13-17

TECHNICAL BULLETIN

Power Windows – Noise During Initial Movement – Install Revised Motor

MODEL 1995 MY Sedan Range VIN 720001-754304

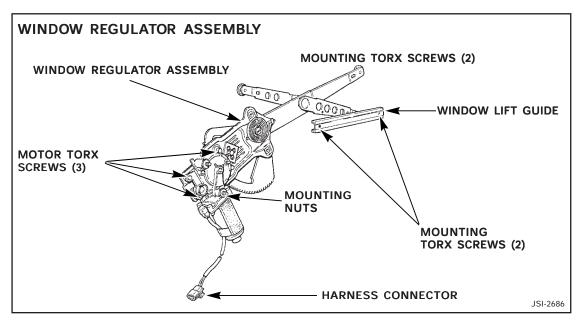
A noise may be heard during initial movement of a window lift mechanism on some Sedan Range vehicles within the above VIN range. To correct this condition, a revised window regulator motor was introduced in production starting with VIN 754305.

In case of a customer complaint of noisy power window operation on a 1995 MY Sedan Range vehicles within the above VIN range, replace the window regulator motor as described below.

- 1. Remove the veneer panel, and upper and lower trim pads.
- 2. Using a suitable plastic knife, cut through the sealant bead which holds the water deflector to the inner panel of the door. Move the water deflector aside to allow access to the lift mechanism.
- 3. Tape the window glass in place using a length of suitable adhesive tape over the upper door frame and fastening it firmly to the glass.
- 4. Loosen and remove the two torx head screws and the two nuts that retain the window regulator assembly (Illustration 1).

- After marking their position, remove the two screws that retain the window lift guide (Illustration 1).
- Remove the harness connector (Illustration 1) from the retaining clip and then disconnect the harness from the motor.

- Loosen and remove the three torx head screws (Illustration 1) that retain the motor to the regulator assembly and then remove the motor.
- 10. Place the new motor on the regulator assembly, using care to fully engage the drive pinion and the segment before installing and tightening the retaining screws.
